**Service Bulletin**

S.B. No: 188

**Title:** INSPECTION FOR RUDDER PEDAL CLEARANCES BETWEEN RUDDER PEDALS AND THE AIRCRAFT STRUCTURE AND COMPONENTS

**Applicability:** T67B, T67C series, T67M (excluding works no. 1999), T67M-MkII and T67M200 (excluding works no. 2264 & 2265).

RUDDER BAR END FLOAT AND ITS SUPPORT BRACKET

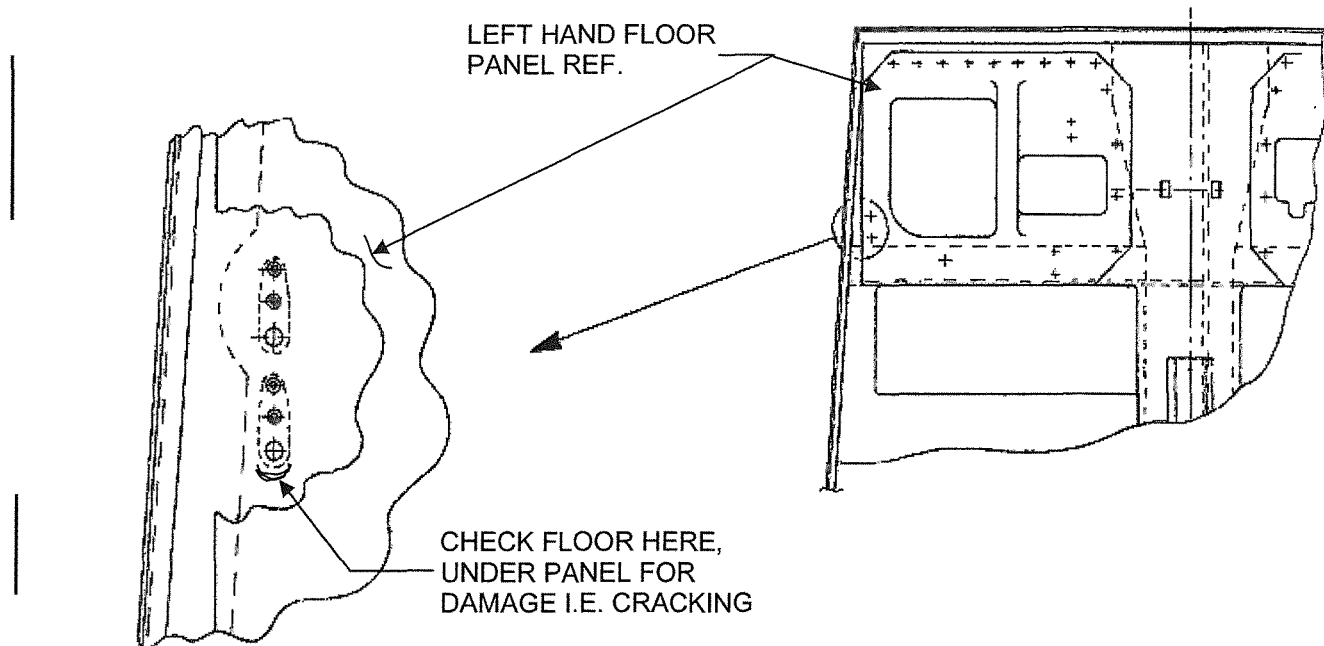
3. Check rudder pedal bar end float is no greater than 0.8mm. Acceptable end float is 0.0mm to 0.8mm. If end float is greater than 0.8mm then rectify end float IAW paragraph 8. Refer Figure 1.

4. Check that the Rudder Pedal bar port outboard support bracket, ref. Figure 1 and 3, is square to the floor and not "lozenged" and there is no deformation to its base. Check floor panel under area of bracket, inspect for cracking which could allow the bracket to lean. If necessary remove floor panel and check for signs of cracking in the floor around the anchor nuts on Pre Mod M919 aircraft or the anchor nut mounting plate Post Mod M919 aircraft, refer Figure 2. Any GRP damage will be shown as a white shadow on the GRP, with cracking felt as a rough edge. A light shining up through the floor will show a shadow.

6. Should Rudder bar support bracket be damaged replace with new item. Ensure bracket is secured with a torque of 58lbf in (6.5Nm). Spring washers may be fitted; Mod M720 "Introduction of Spring Washers to Rudder Pedal Lay-shaft Mounting Bracket Screws" refers. See Figure 1. Ensure when refitting brackets that the saddle washer, T67M-45-537, is re-fitted and is assembled with its corner radius into the brackets radius, refer Figure 1. Ensure that the taller mounting brackets are supporting Rudder Pedal Bar T67M-45-257, i.e. Port Rudder Bar, refer Figures 1 and 3.

8. Referring to Figure 1 ensure at each rudder bar pivot position that there is one spacer T67M-45-507 OR one off washer 126-23-748 and up to a maximum of two off washers 126-23-749, i.e. 3 washers maximum.

- If end float greater than 0.8mm, then 1 off packing washer may be added at each pivot position as required, i.e. 126-23-105 washer or 126-23-748 washer or 126-23-749 washer.

FIGURE 3

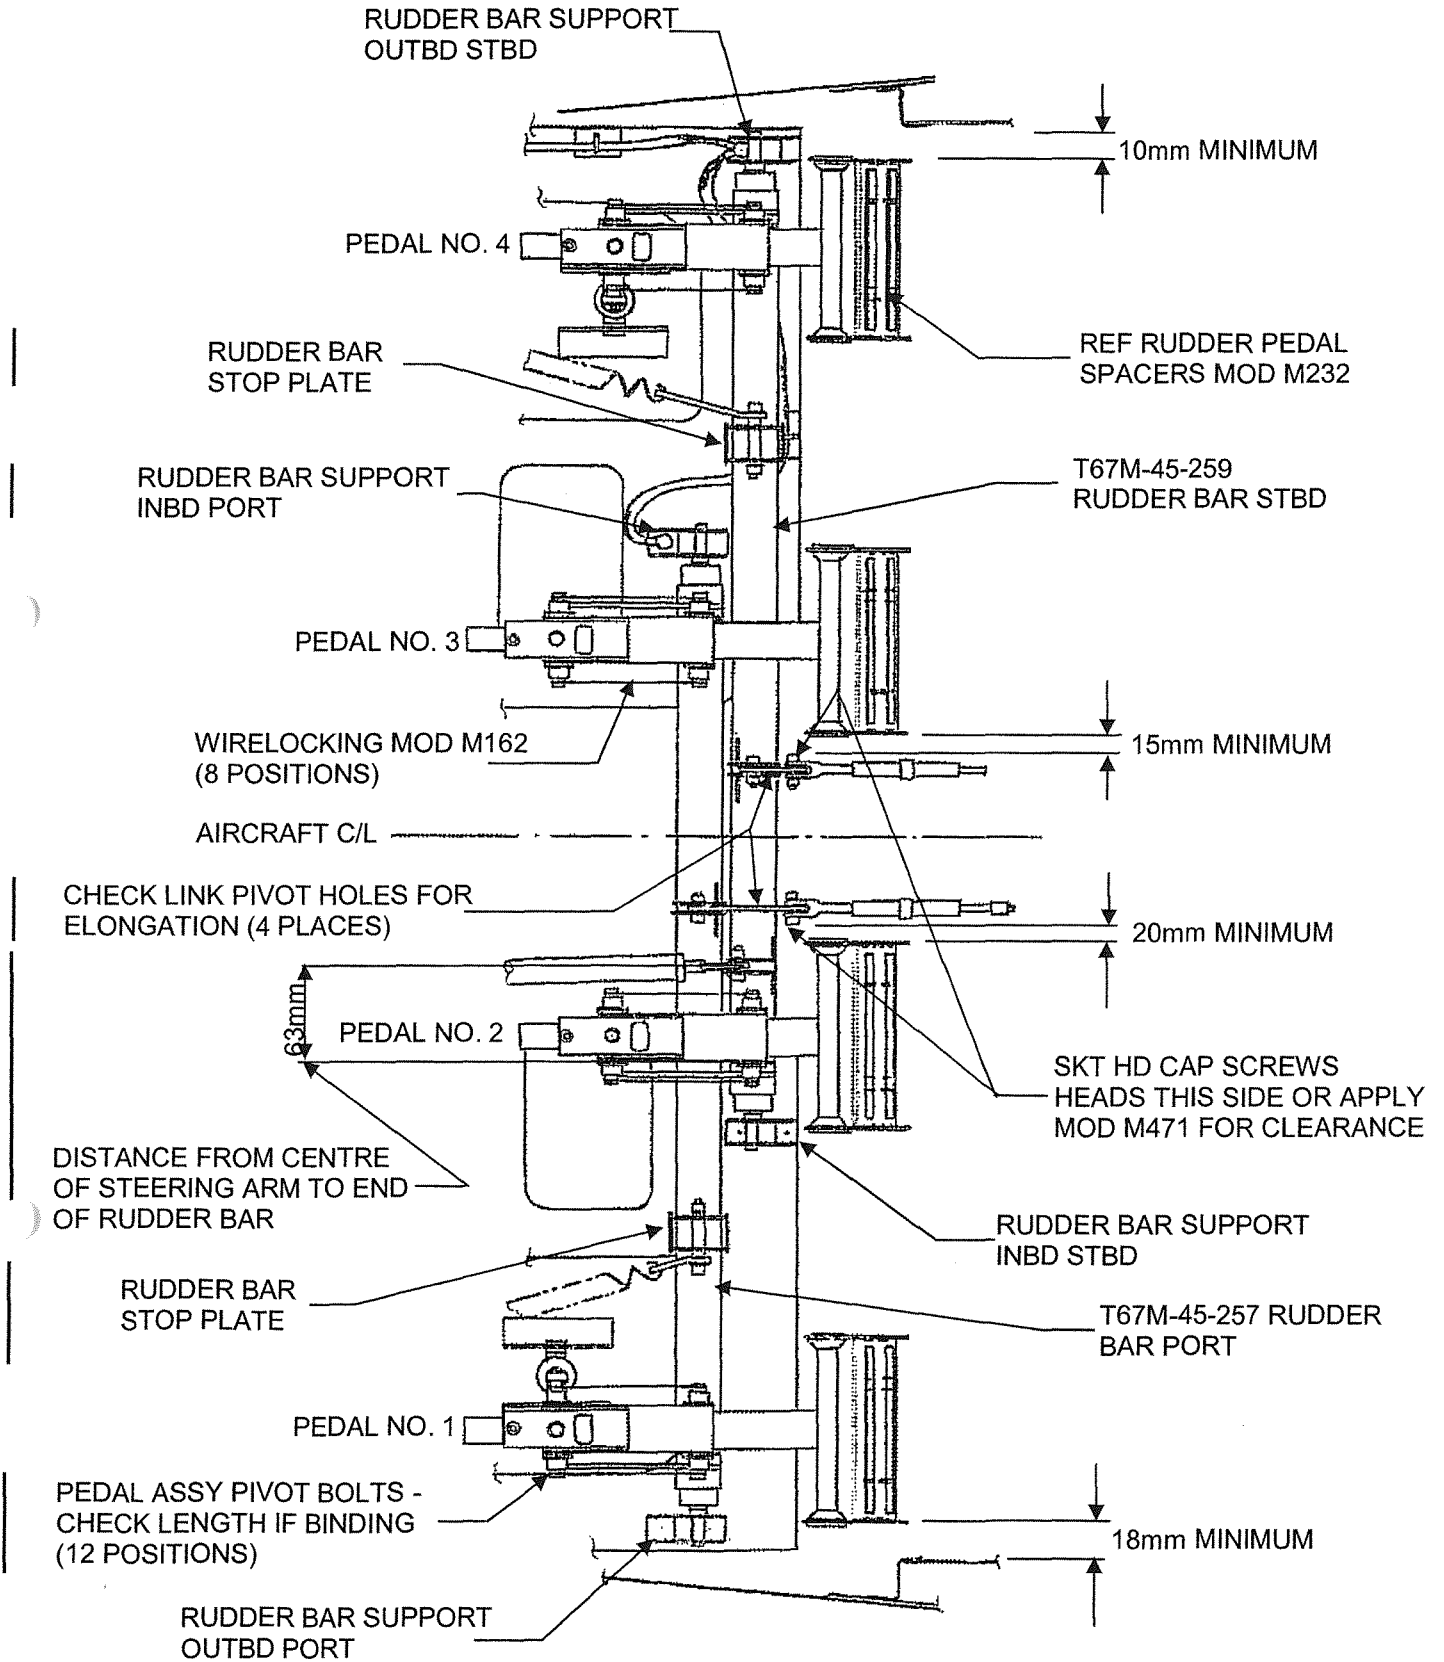
Note 2: Note rudder stop plates, positions indicated on Figure 3, are permitted with deformation assuming full rudder movement and clearances have been achieved and there is no cracking in the welds supporting the stop plates, if in doubt return rudder bar to SACL for rework.

13. Upon completion of rudder movement set-up ref. Paragraph 11 above. Ensure minimum clearances of trim panel to pedal side plates and rudder cable to pedal side plates are met Figure 3 refers. If necessary to obtain the required clearances, Mod M232 "Introduction of Rudder Pedal Packing for Increased Clearance of Surrounding Components" may be required to be invoked. Refer paragraph 7 for packing washers on rudder bar.

15. Ensure head orientation of rudder cable link bolt head is outboard, Figure 3 refers, this is a Low Pan Head bolt T67M-45-570 on Post Mod M471 "Introduction of Pan Headed Bolt on Rudder Cable Turnbuckles", aircraft.

20. Ensure rudder pedal carriage socket head caps screws are wire locked and bonded in with adhesive 126-51-024, use minimum amount, Mod M162 "Wire Locking of Rudder Pedals – Upper Pivots", refers. See Figure 3.

FIGURE 4

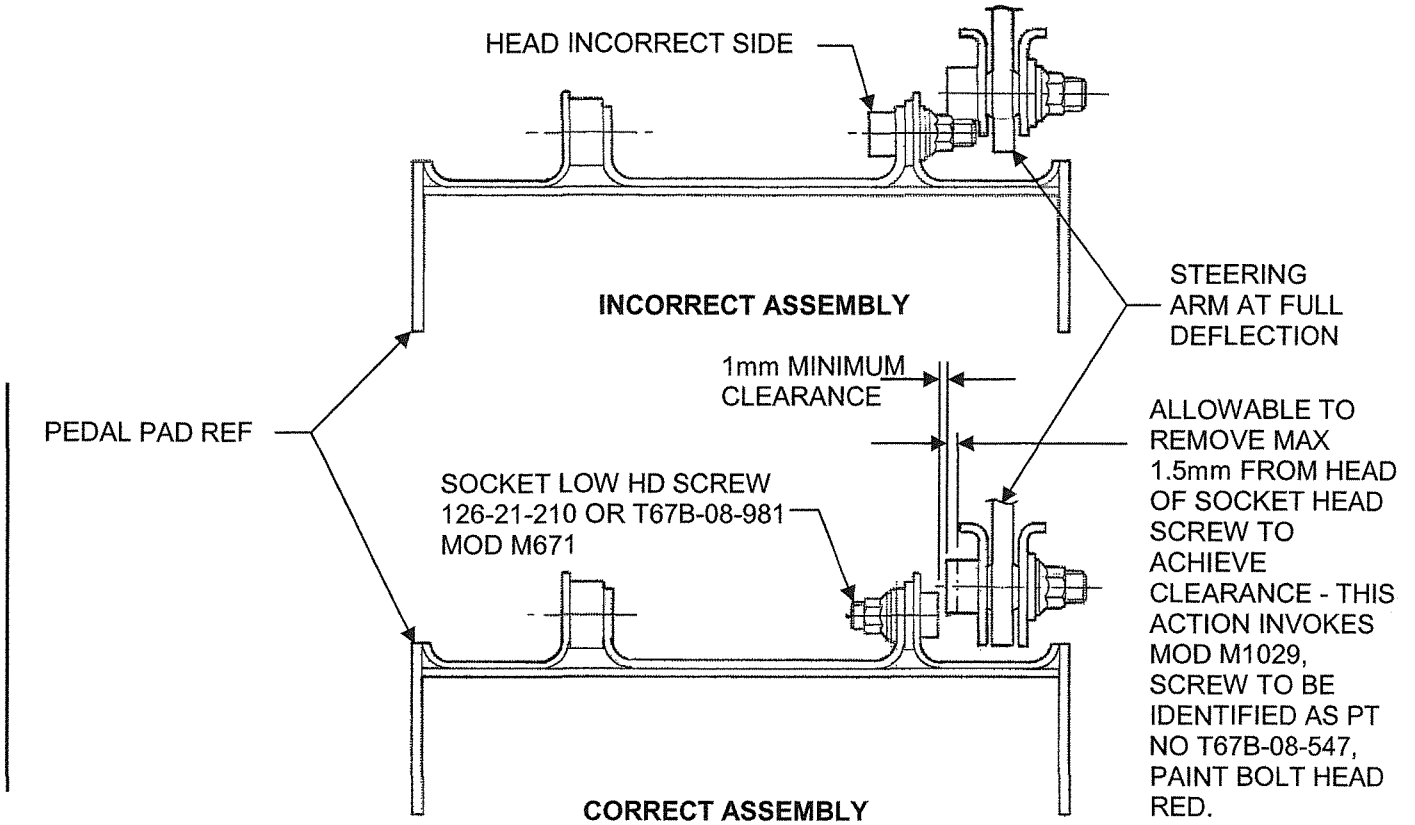
16. Ensure Pedal no 2 Pedal pad pivot bolt head height is less than 5mm and orientated as shown in Figure 4. A minimum of 1mm clearance is required, if not fit part no 126-21-210 or T67B-08-981, this invokes Mod M671 "Introduction of Low Head Rudder Pedal Pad Pivot Bolts – Pedal No. 2". If clearance is not still achieved check distance of steering arm from bar end, Figure 3 specifies. If the distance is incorrect, then return rudder bar to SACL for re-worked/new item. Alternatively if clearance of 1mm is still not achievable remove up to a maximum of 1.5mm from the steering arm screw this invokes Modification action M1029, Figure 4 refers, and paint modified screw head red.

FIGURE 5

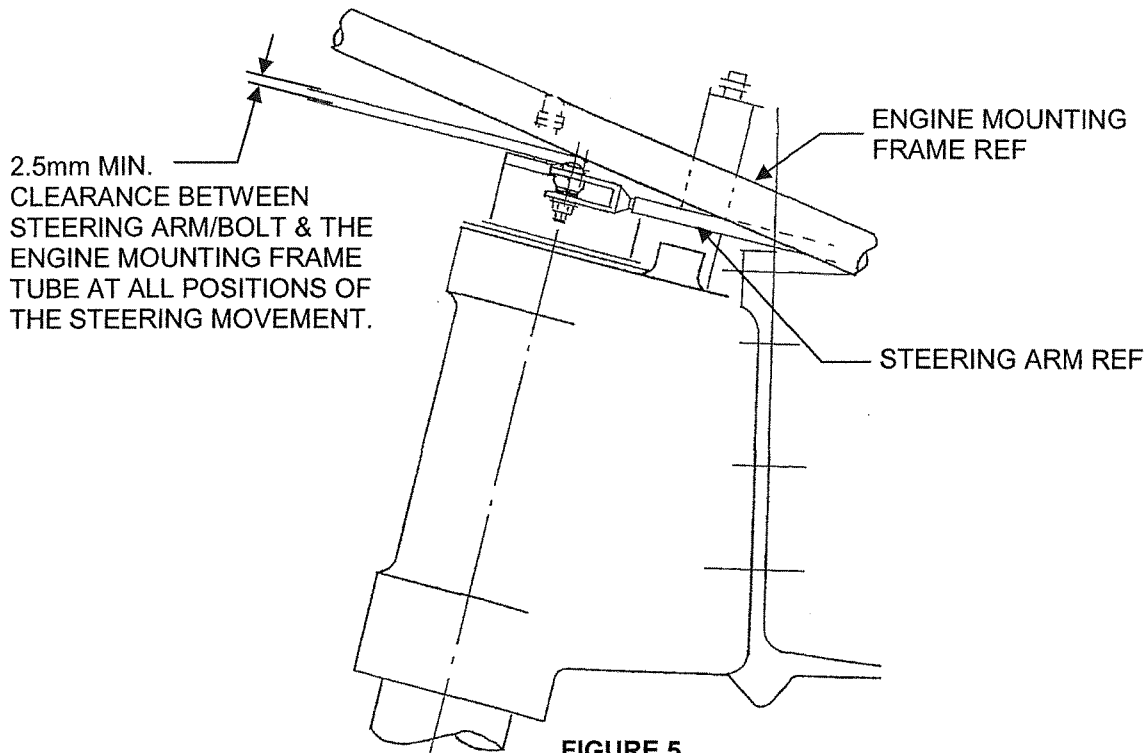
21. Ensure on aircraft fitted with the Fairey Hydraulic undercarriage, (Post Mod M468 or Mod M791), that there is a minimum clearance of 2.5mm with steering linkage to engine mounting frame, see Figure 5. Ensure there is no damage to engine mounting frame if clearance is less than 2.5mm. If engine mounting frame is damaged then aircraft must not be flown until damage is rectified, consult SACL. Also if clearance is less than 2.5mm embody Mod M575 "Introduction of Offset Steering Arm Pin – Ref Fairey Hydraulics Nose U/C", if Mod M575 is fitted and clearance is less than 2.5mm inform SACL.

**FIGURE 6**

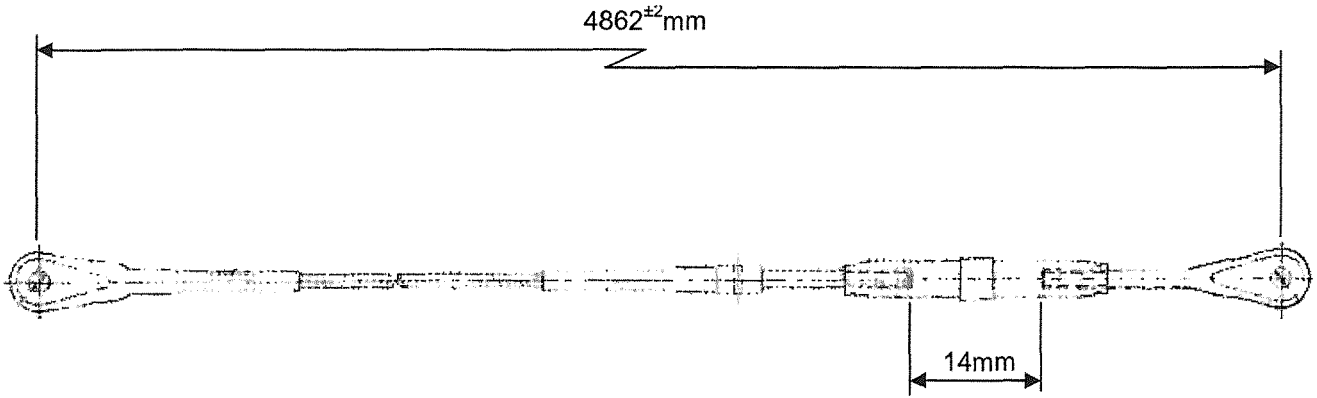
14. Ensure fuel pipe to rudder pedal slider clearance of is met, refer relevant aircrafts Maintenance Manual Paragraph, 5.6.5.1, where relevant the minimum acceptable clearance is now to be 5mm. If clearance cannot be achieved then; i) remove Rudder Cable and check length, length should be 4862  $\pm$  2 mm, Figure 6 refers; ii) additionally check condition of rudder pedal assembly, refer paragraph 2.

FIGURE 7

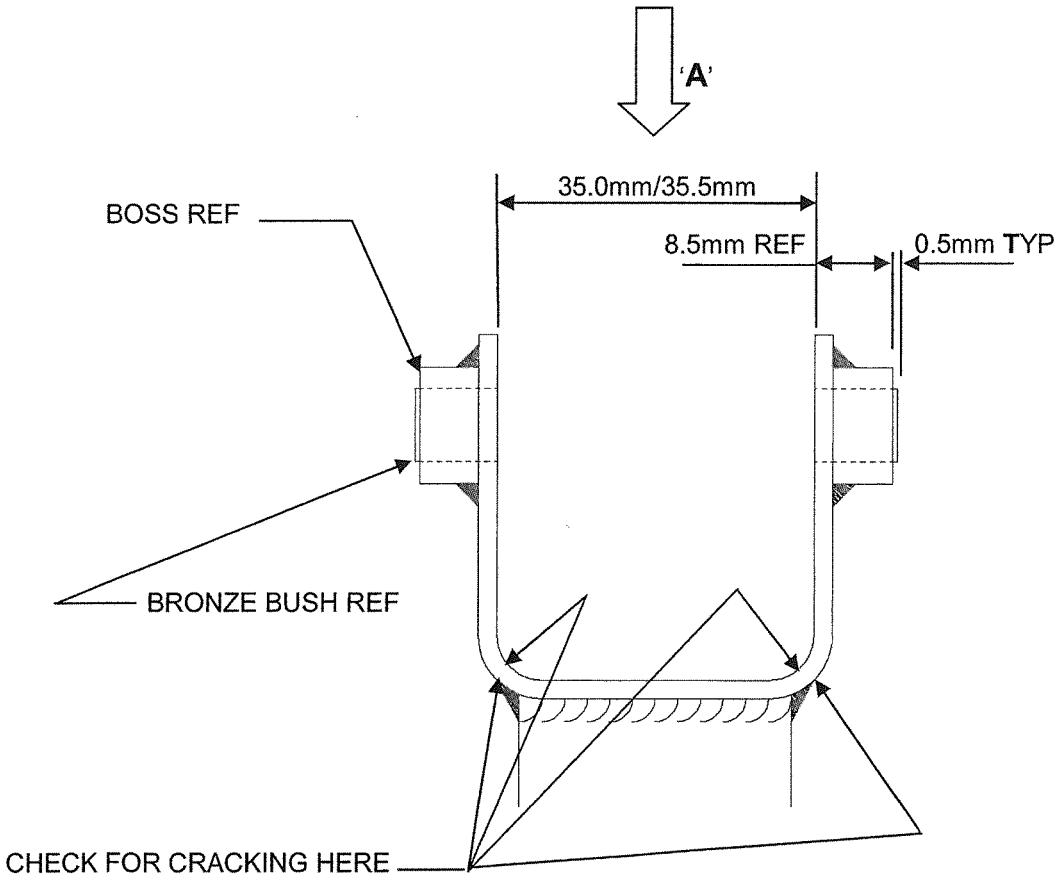
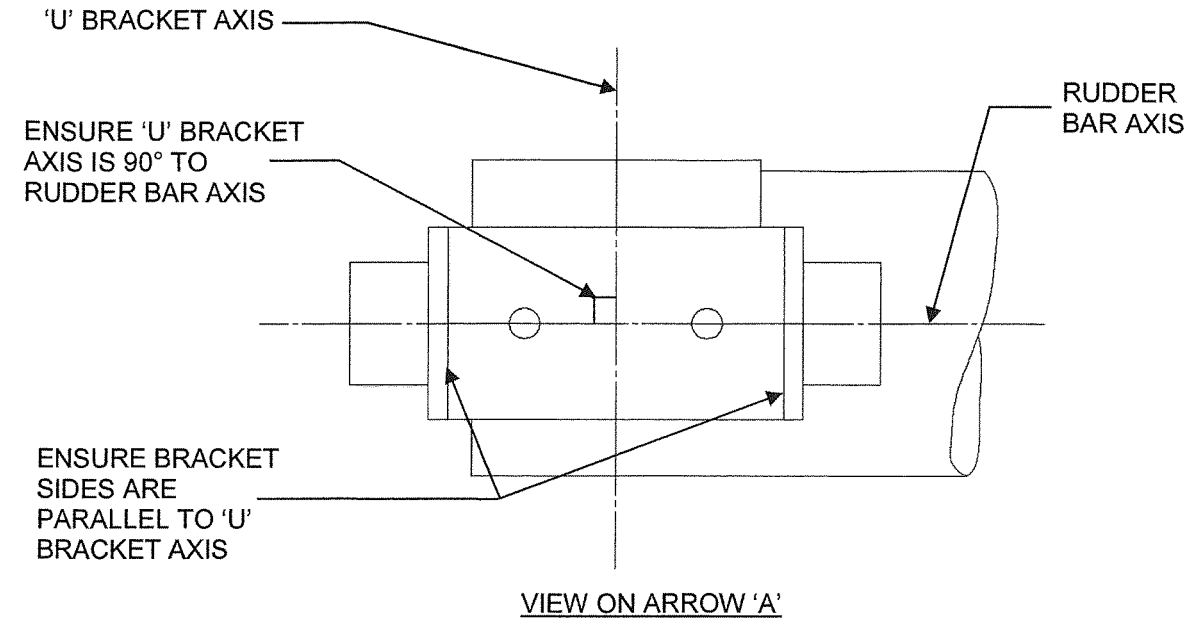
9. Ensure the rudder pedal carriages have full and free movement. If binding is suspected then check the 'U' bracket internal dimension. This should measure 35.0mm to 35.5mm, the bracket should also be parallel and square to the rudder bar axis, Figure 7 View on 'A' refers. Check that the pivot bush protrudes from its boss by 0.5mm. If the bracket internal dimension is greater or less, or if out of alignment then the bracket should be checked for cracking, refer Figure 7. If cracking is found then return rudder bar to SACL for rework. Finally check length of carriage pivot bolts, reference Figure 3, if binding is noted then replace bolts with bolt part number T67B-08-537 this introduces a bolt 15 mm long, measured from under head, and invokes Mod M808 "Introduction of Shortened Pivot Bolt to Rudder Pedal Slider Assembly Mounting". Also refer to SB130 Inspection of Rudder Pedals for Adjustment Restriction".

FIGURE 8

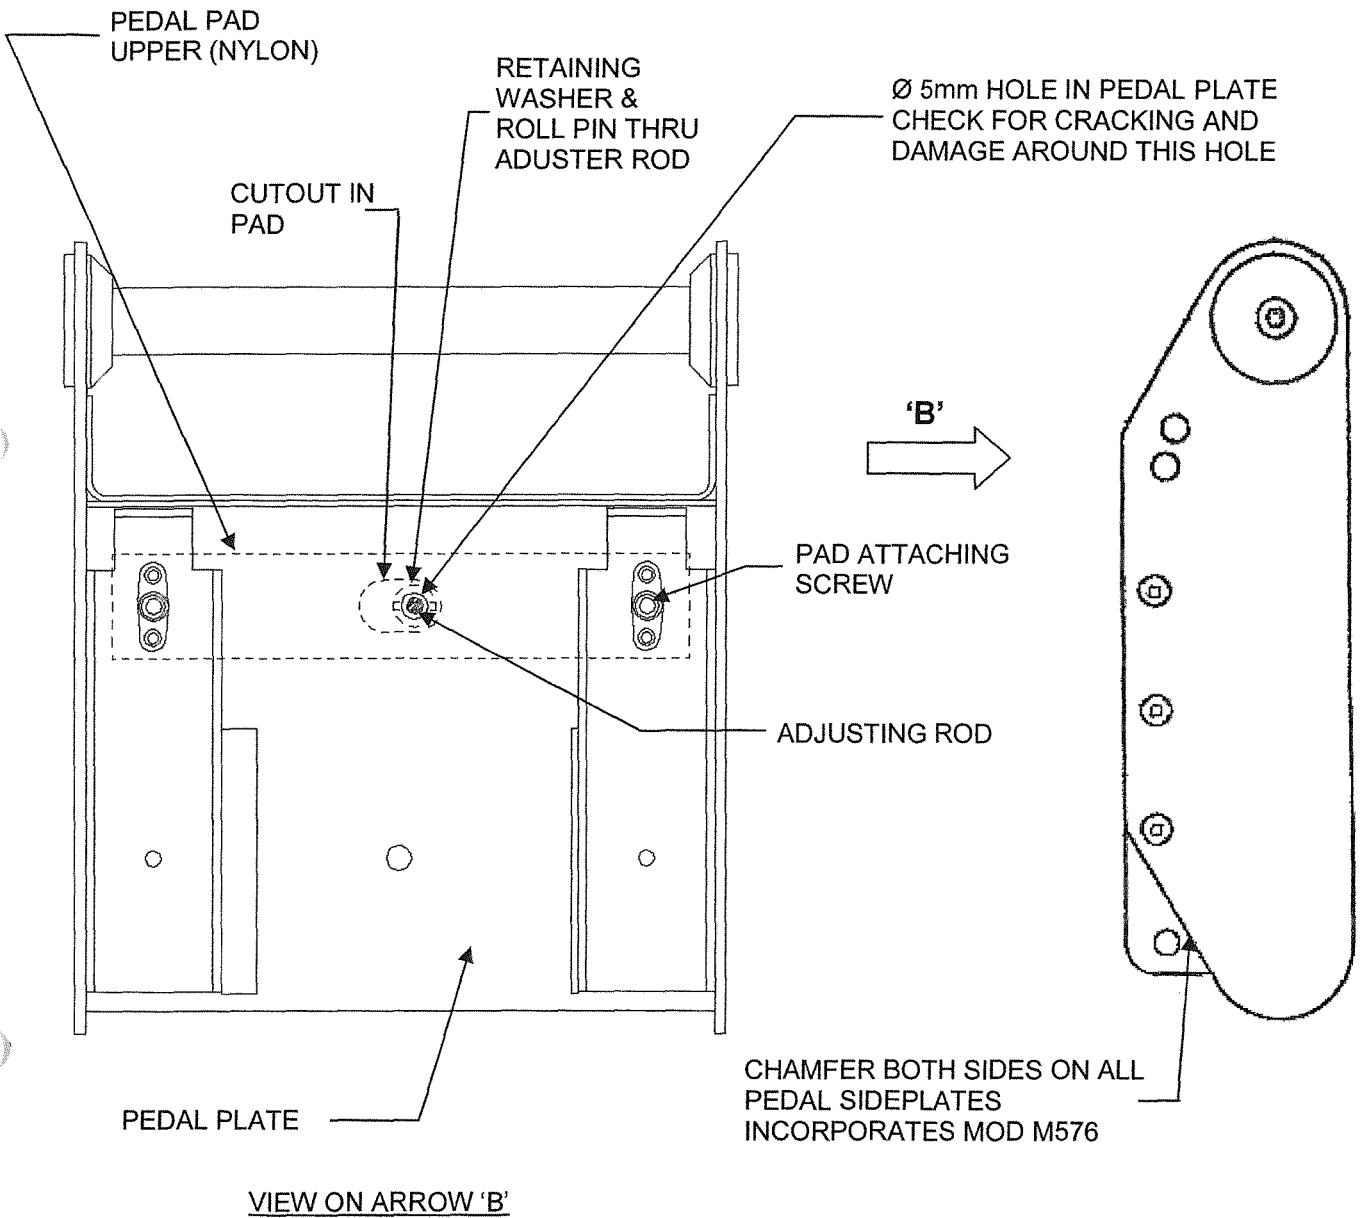
18. Ensure Mandatory Mod M576 has been invoked; AD 013-05-94 refers. Pedal side plate should be as Figure 8.
19. Check structural integrity of pedal pad assembly especially around adjuster pushrod hole pedal plate, Figure 8 View on Arrow 'B' refers, if plate is cracked or damaged the pedal pad is to be repaired. Ensure riveting is secure, if rivets are loose then they have to be rectified. Contact SACL for new pedal pad assembly, materials and any applicable repair scheme.
